# Cherry Orchard Point

Quality Audit

JOB NUMBER: 230062			DOCUMENT REF: 230062RPT002_QA_Rev_1			
Revision	Purpose Description	Originated	Checked	Reviewed	Authorised	Date
1	Final Issue	MD	CJP	MD	MD	19 Oct 2023
0	Draft Issue	MD	CJP	MD	MD	11 Aug 2023

**Figure 3.1 – Examples of Where Parked Vehicles Could Impact Upon Crossing Safety**

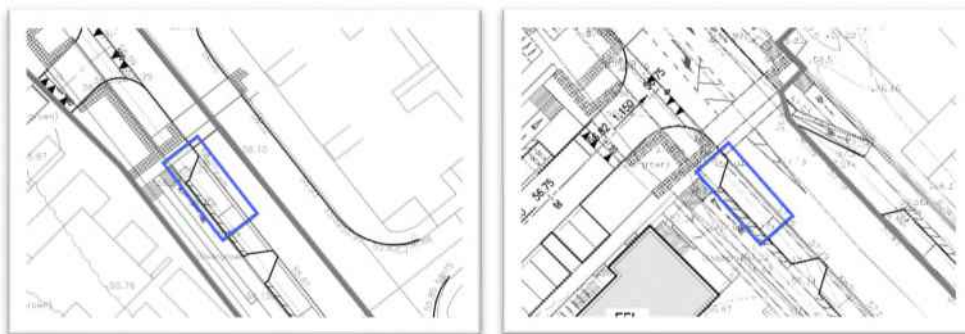
**Drg. | Location: P101, P102, P103 | Signal Controlled Pedestrian Crossings**

The proximity of parking spaces to the adjacent pedestrian crossing could result in a parked car (or high-sided van / SUV) obscuring intervisibility between a pedestrian and an approaching vehicle. This is likely to increase the risk of conflict between vulnerable road users and vehicles.

Parking spaces on approach to all pedestrian crossings should be checked and adjusted as appropriate to maximise intervisibility between a pedestrian and an approaching vehicle.

Problem Reference (Section 3)	Designer Response Section			Audit Team Response Section
	Problem Accepted (yes / no)	Recommended Measure Accepted (yes / no)	Alternative Measures or Comments	Alternative Measures Accepted (yes / no)
3.1	Yes	Yes	<p>There are 2 No. proposed junctions on Park West Avenue with pedestrian crossings. The layout of these junctions have been reviewed and revised. The parking bays adjacent the crossing on the northern junction have been relocated as has the crossing itself.</p>  <p>The parking bays adjacent the crossing of the southern junction have also been relocated.</p>  <p>These relocations provide an extended buffer zone between pedestrian crossings and parking bays, further enhancing intervisibility</p>	Comment noted.

**Figure 3.2 – Examples of Where Parking Could Impact Upon Safety at Priority Controlled Junctions**

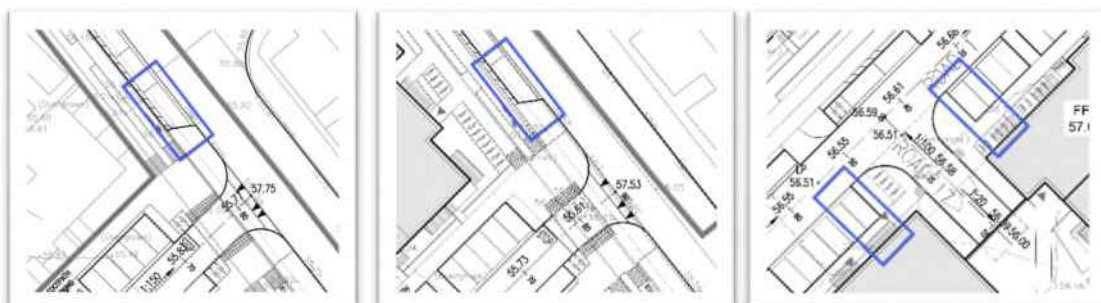
**Drg. | Location: P101, P102, P103 | Priority Controlled Junctions**

The proximity of parking spaces to an adjacent priority controlled junction could result in a parked car (or high-sided van / SUV) obscuring the junction’s envelope of visibility. This is likely to increase the risk of conflict between all road users at the junction.

Parking spaces in proximity to all priority controlled junctions should be checked and adjusted as appropriate to maximise each junction’s envelope of visibility.

3.2	Yes	Yes	<p>There are 3 No. priority junctions as part of the proposed development, 2 No. on Park West Avenue, and 1 No. entering/exiting the retail carpark.</p> <p>Sightline analysis has been undertaken on all these junctions.</p> <p>For the 2 No. priority controlled junctions on Park West Avenue, it is intended that the centreline roadmarkings will be formed by a solid white line, preventing overtaking. The sightline has been measured to the centreline of the road for traffic approaching the small arm of the junction from the left hand side. Visibility to vehicles approaching from the left is clearly facilitated.</p> <p>It is accepted that the sightlines do “clip” the parking bays on the right hand side to a certain extent however, the outline of a large family car (length 5.1m), indicates that the full sightline is provided. Visibility may be reduced in the event that high sided delivery vehicles occupy the space, and as such, temporary loading bays are facilitated elsewhere onsite to mitigate against this occurrence.</p> <p>For the junction entering/exiting the retail carpark, parking bays have been shifted to optimise visibility splays. It is noted that for a road design speed of 30KPH, full visibility of 23m is not provided, however, given the short length of straight road approaching this junction from the south (due to road curvature), and the north (from the junction) it is felt that a max achievable speed of 20KPH is more realistic and a required sightline of 14m for this design speed has been mostly achieved.</p> <p>Sightline analysis is shown in its full revision on Drawing Number: 22-010-P130.</p>	Comment noted.

**Figure 3.3 – Cul de Sacs without Provision for Vehicles to Turn**

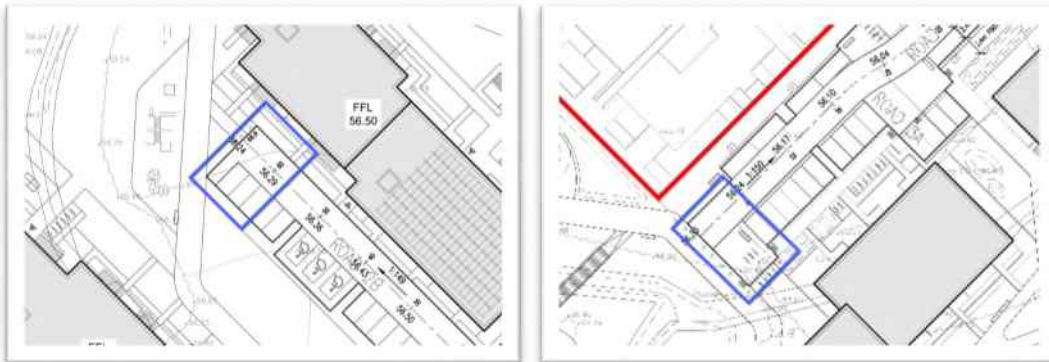
**Drg. | Location: P101 & P102 | Cul de Sacs on Road 2b & Road 3**

The absence of a vehicle turning head at the end of the Cul de Sac's is likely to result in driver frustration, poor decision making and extended reversing manoeuvres which may lead to conflict with vulnerable road users.

Appropriate provisions should be made for vehicles to turn at the end of the Cul de Sacs.

3.3	Yes	Yes	Provisions have been made to incorporate turning heads to the layout on cul-de-sacs. Please refer to Drawing Numbers: 22-010-P101 & P102.	Comment noted.

**Figure 3.5 – Locations Where Cycle Tracks Appears to Displace Existing Footpath Facilities**

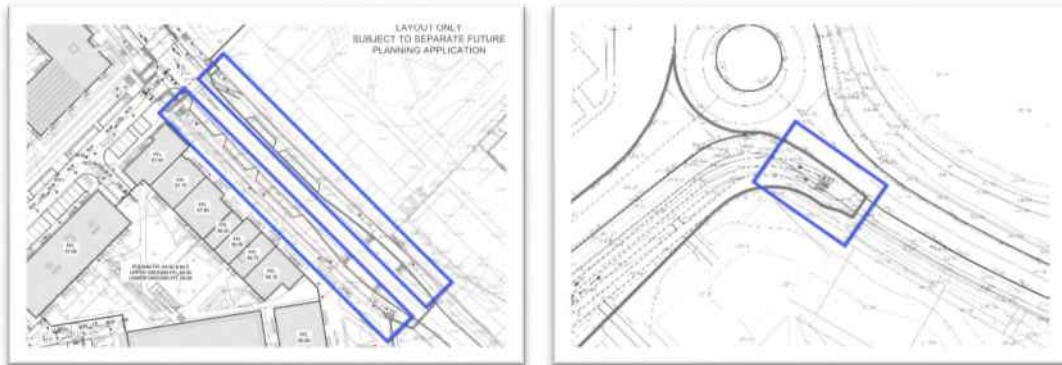
**Drg. | Location: 103 | Park West Avenue & Cedar Brook Way**

The provision of cycle tracks at these location does not appear to retain any space for the existing footpath and therefore pedestrian progression. This could lead to a pedestrian walking in the cycle lane or the traffic lane, increasing their risk of conflict and injury.

Appropriate footpath facilities should be provided at the locations described.

3.5	Yes	Yes	<p>The proposed pedestrian and cycling connection to the existing infrastructure has been revised.</p> <p>The proposed infrastructure now ties in more clearly to the existing. Where cycle lanes end, tactile paving and signage will be provided advising of this and drop kerbing will be installed facilitating cyclist connectivity to rejoin the road surface and cycle lanes.</p> <p>Please refer to Drawing Number: 22-010-P010.</p>	Comment noted.
